Wagga Wagga Base Hospital (WWBH) Stage 3 Redevelopment

Access/DDA Schematic Design Report

Report Ref: AN17-210103 NAC_HI_Wagga Wagga Base Hospital
(WWBH)_SDR04_20180612

Date: 12 June 2018

PROJECT NUMBER: 17022 DRAWING NUMBER: SSD-ACB-1120 ISSUE: 06

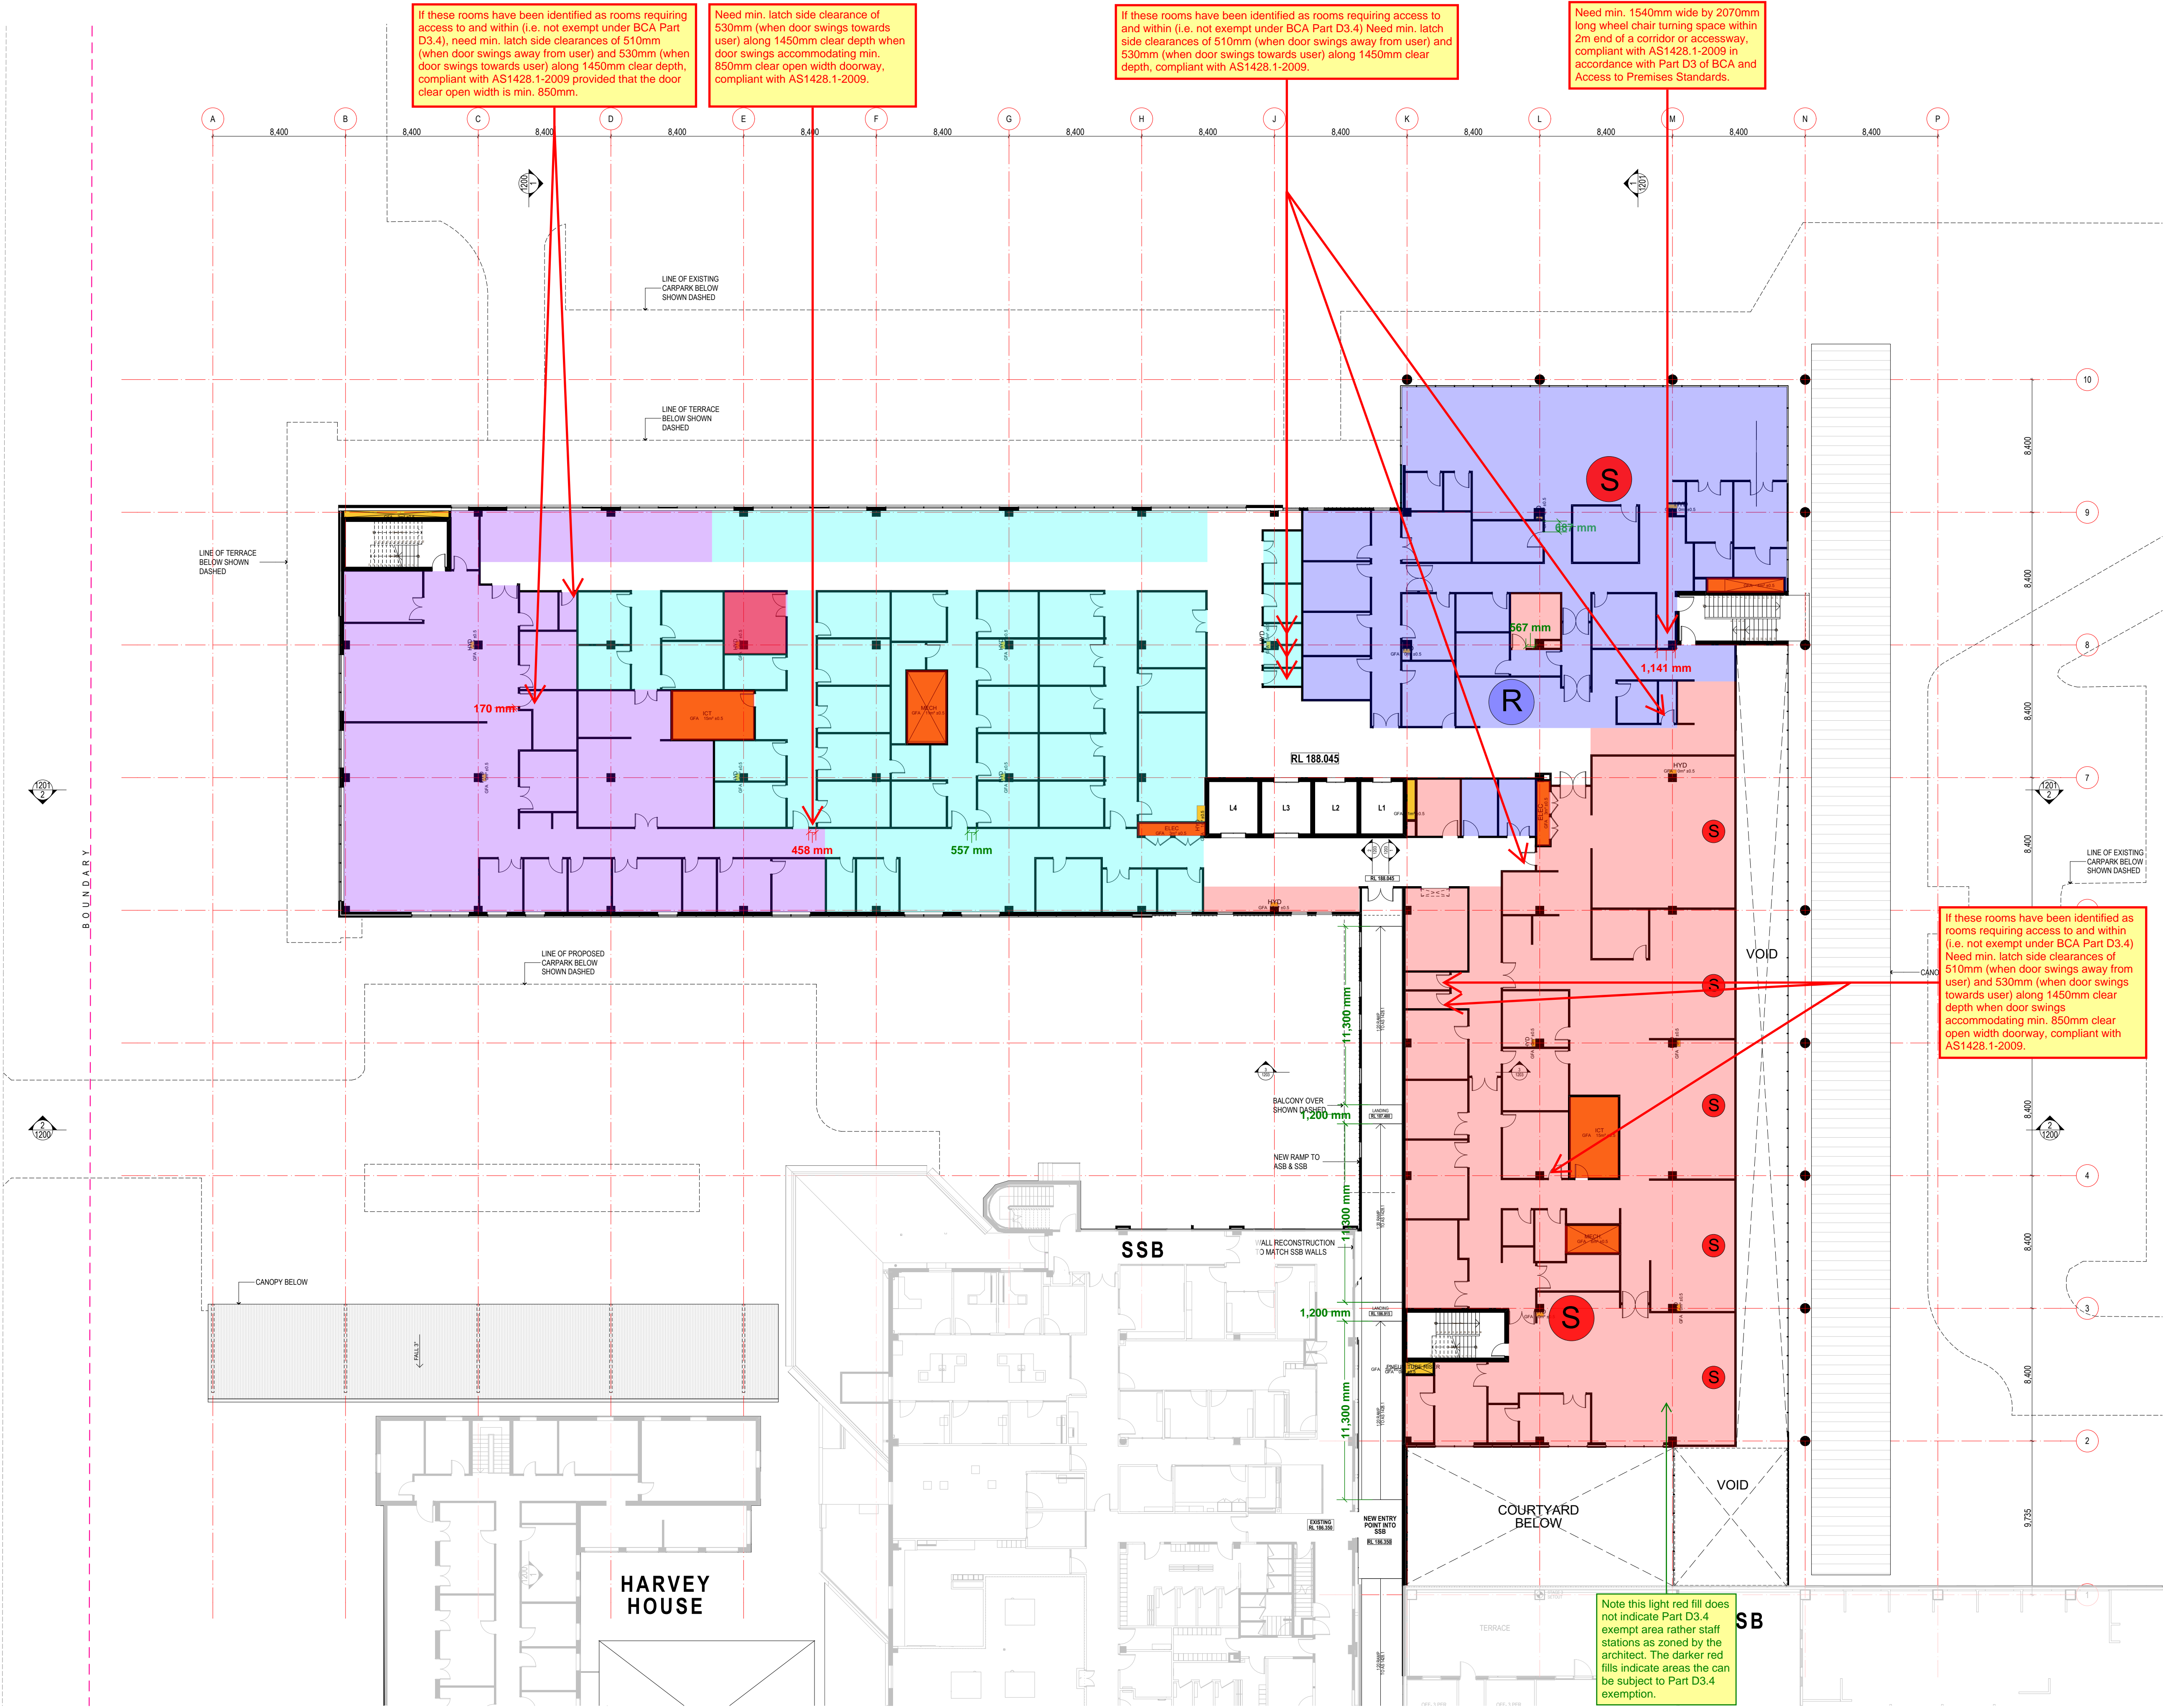
Please identify all rooms and their uses in addition to generic zoning to determine whether access is required to and within or whether it can be exempt under Part D3.4

SCALE: 1:200B A1
DRAWN BY: JR
QA: CM
ISSUE DATE: 7/06/2018
PROJECT NUMBER: 17022
DRAWING NUMBER: SSD-ACB-1130
ISSUE: 06
ref: BIM Server: BIMSERVER - BIM Server: 21/1/2022 20:00pm Wagga Wagga Hospital Stage 3/1/2022 CHL 06/17022 CHL 03

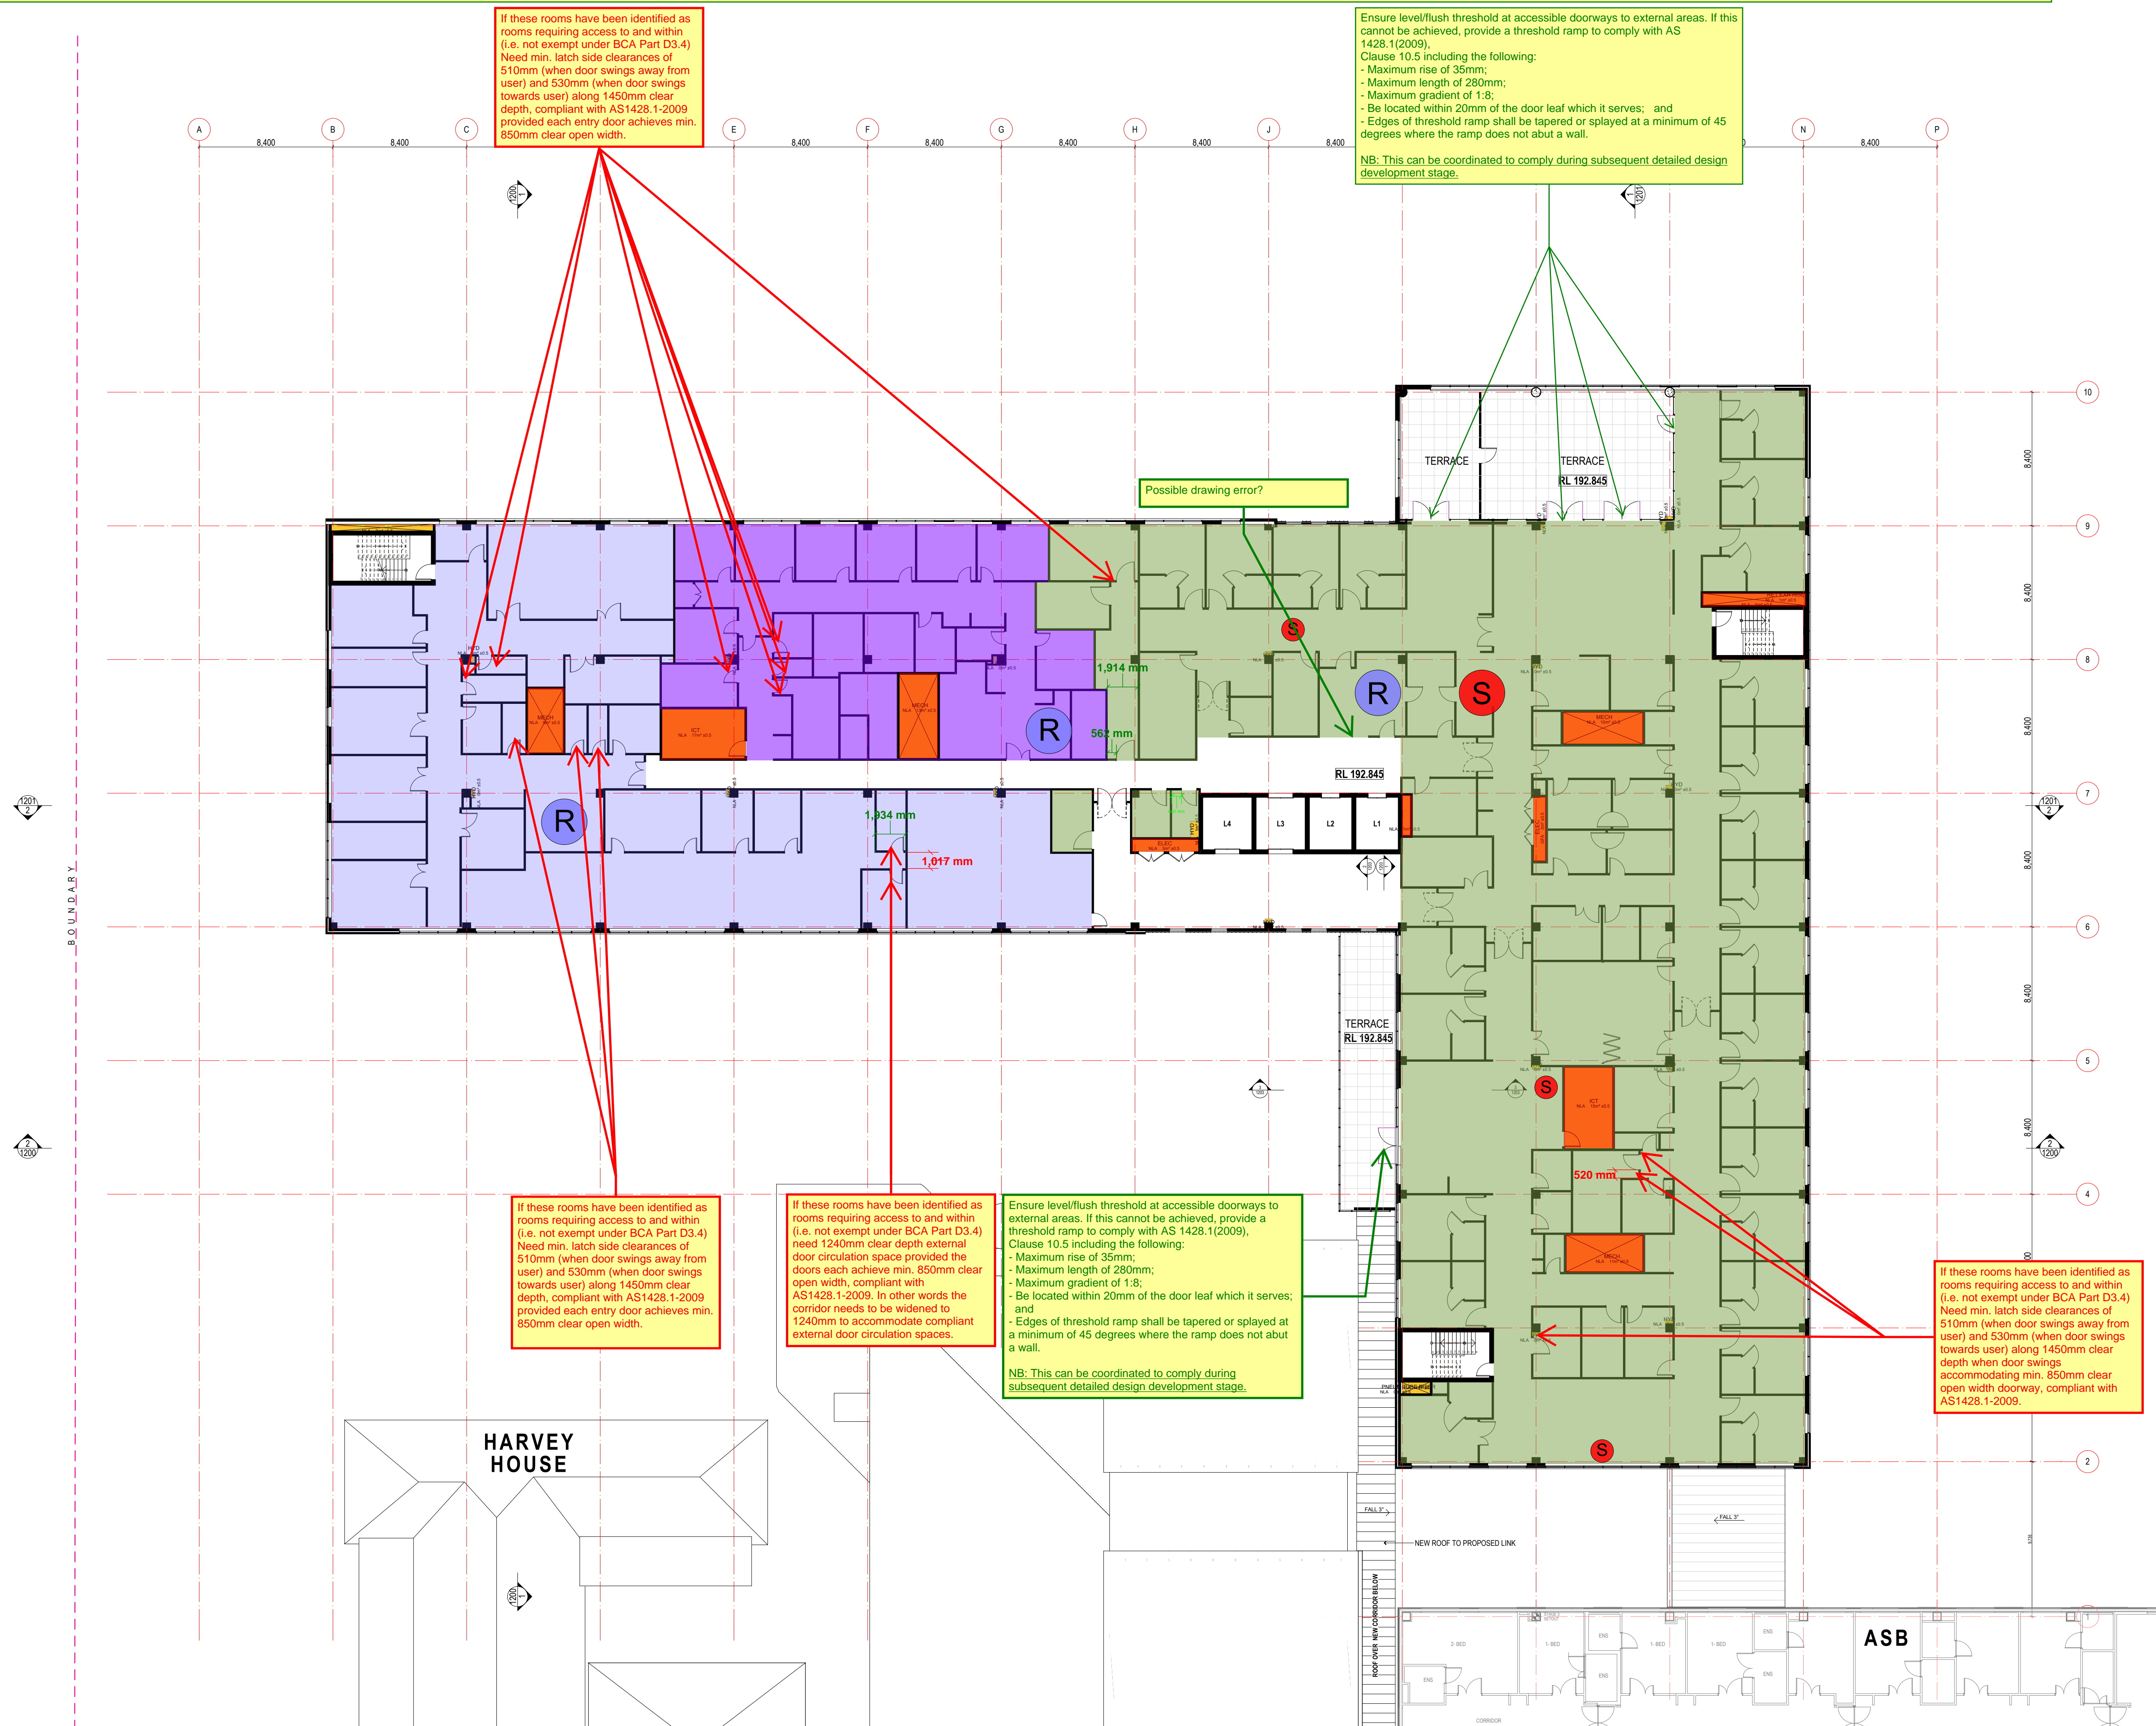
Strongly consider accommodating an offset tread width at the base of each fire-isolated stairway landings (incl. intermediate landing) to ensure at least one consistent height handrail (e.g. inner rail) in line with the intent of Part D2.17 of BCA.

Ensure min. 1m clear path of travel along entire stair flight, landing and egress pathway measured from inner surface of handrail to a wall or obstruction.

SCALE: 1:200B A1
DRAWN BY: JR
QA: CM
ISSUE DATE: 7/06/2018
PROJECT NUMBER: 17022
DRAWING NUMBER: 17022 CH 03
ISSUE: 06

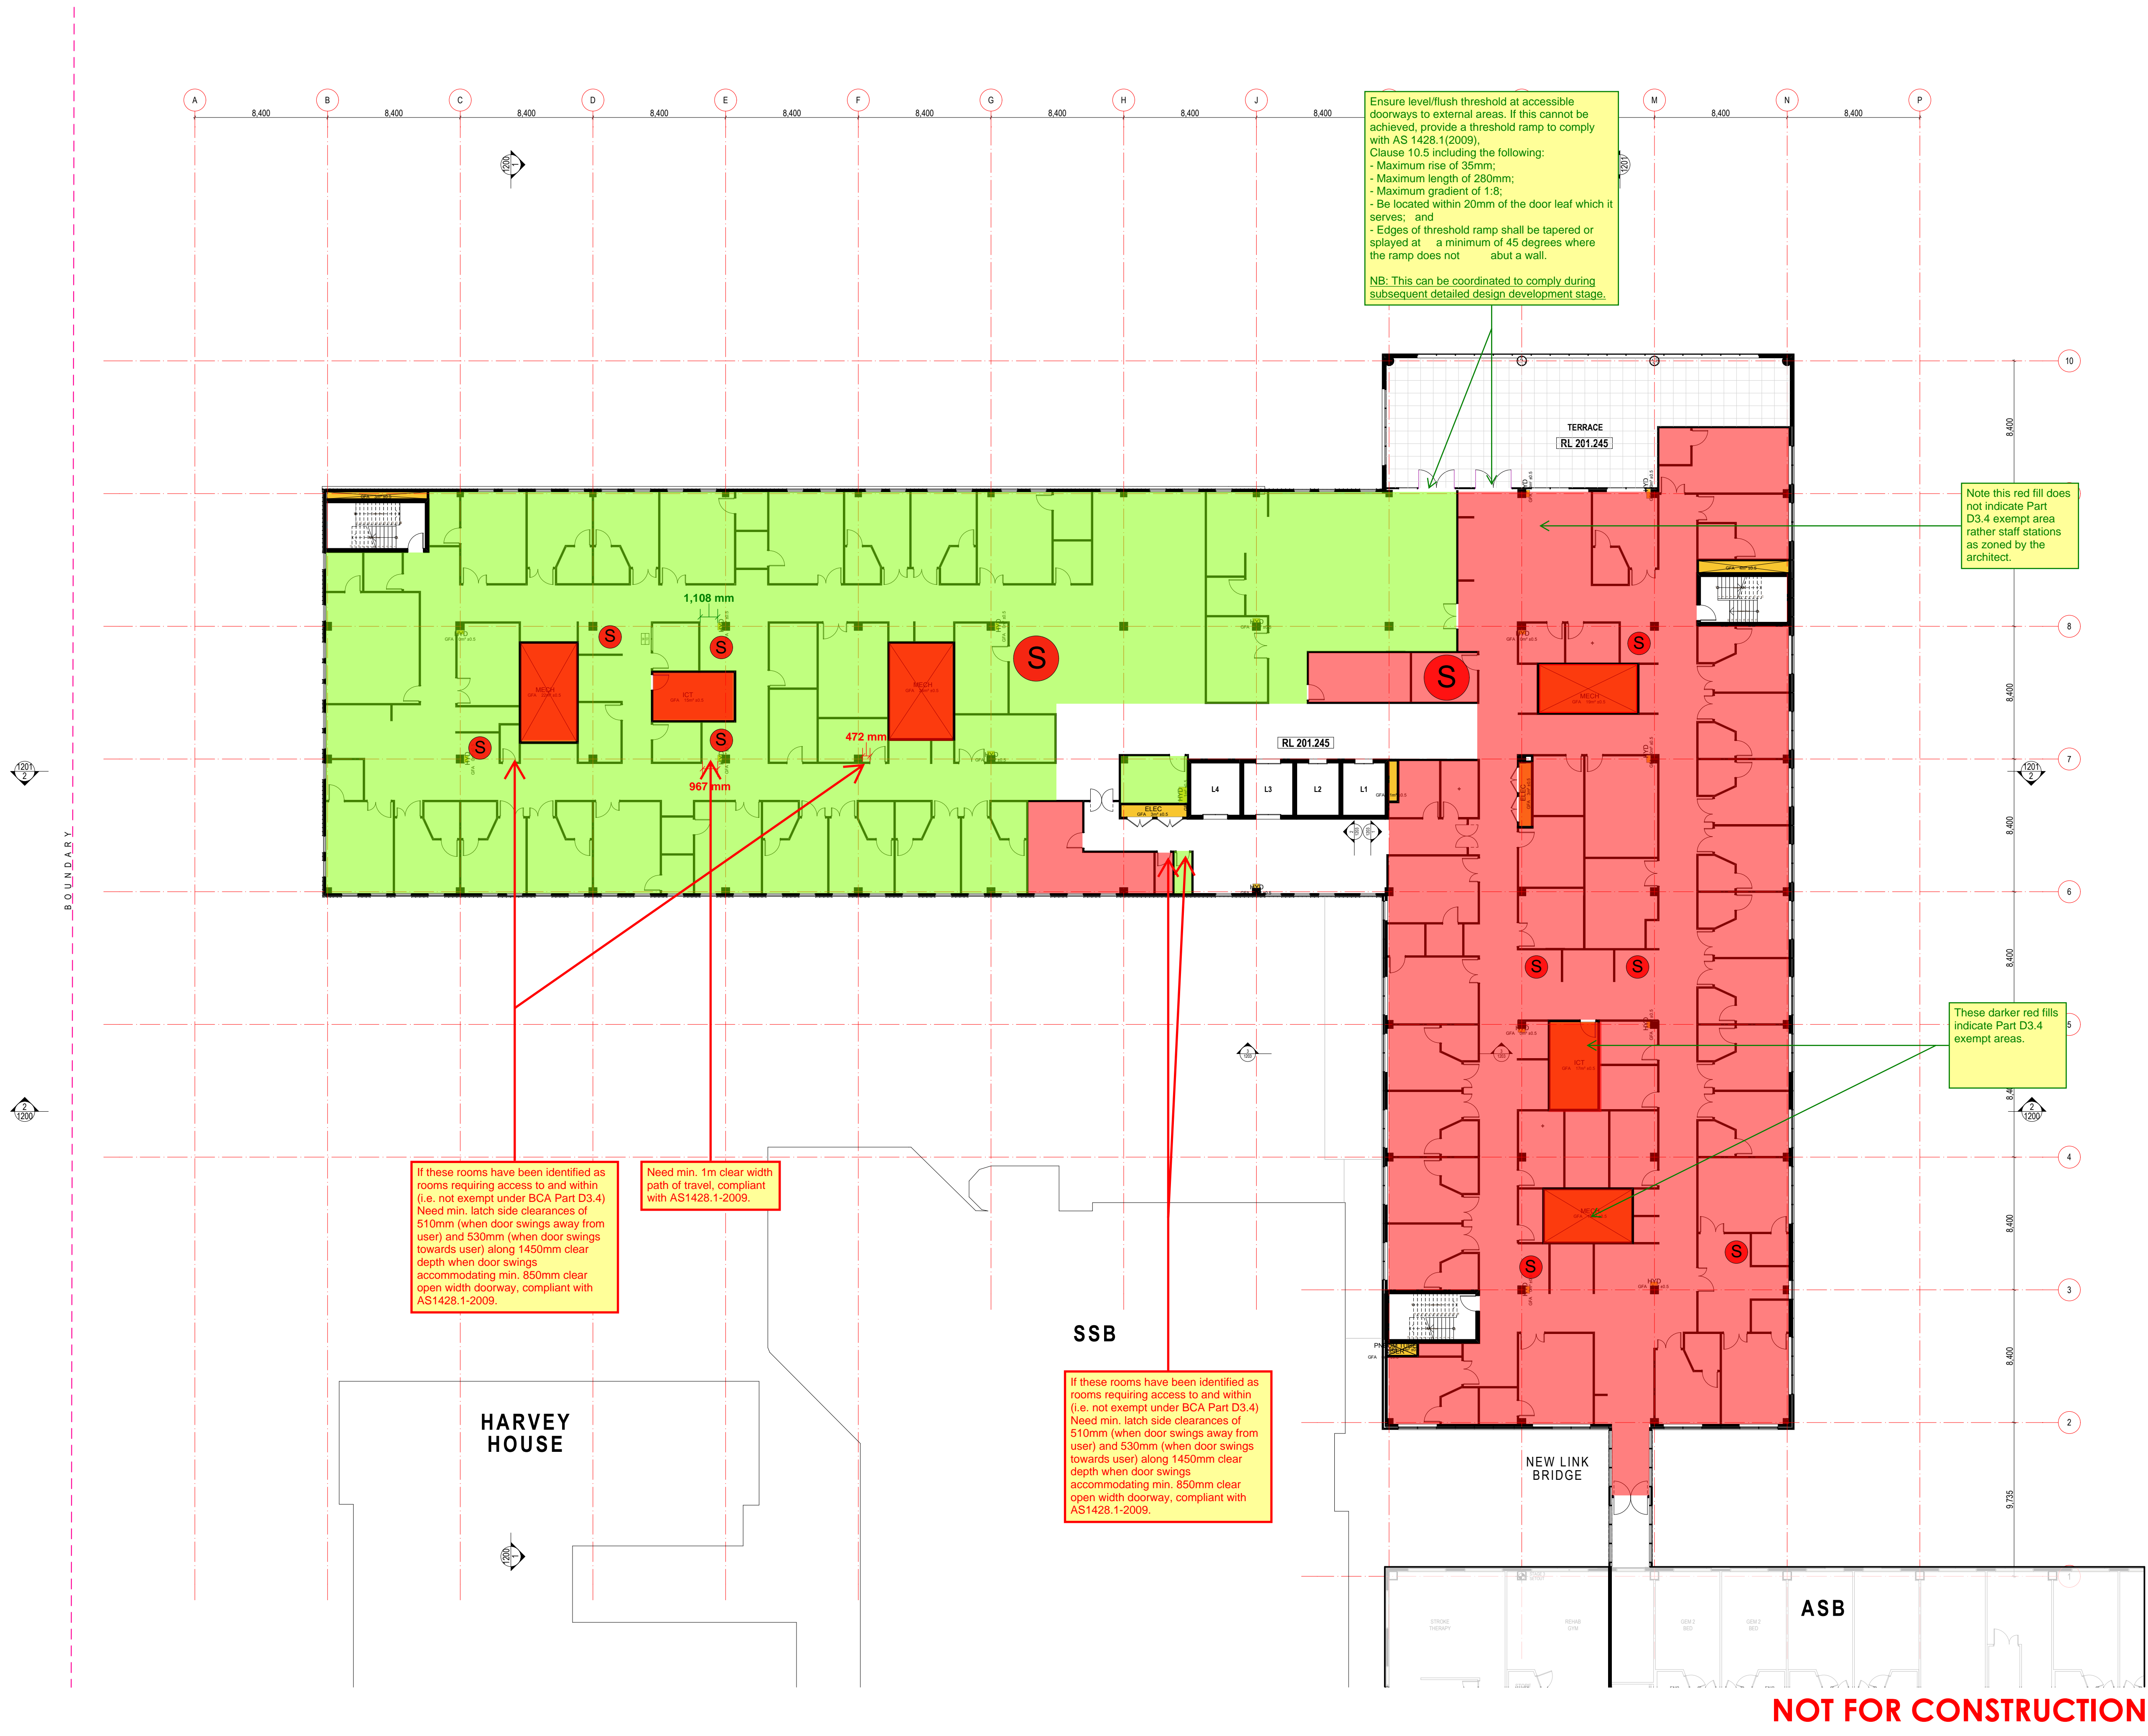
Strongly consider accommodating an offset
tread width at the base of each fire-isolated
stairway landings (incl. intermediate landing)
to ensure at least one consistent height
handrail (e.g. inner rail) in line with the intent
of Part D2.17 of BCA.

Ensure min. 1m clear path of travel along
entire stair flight, landing and egress pathway
measured from inner surface of handrail to a
wall or obstruction.
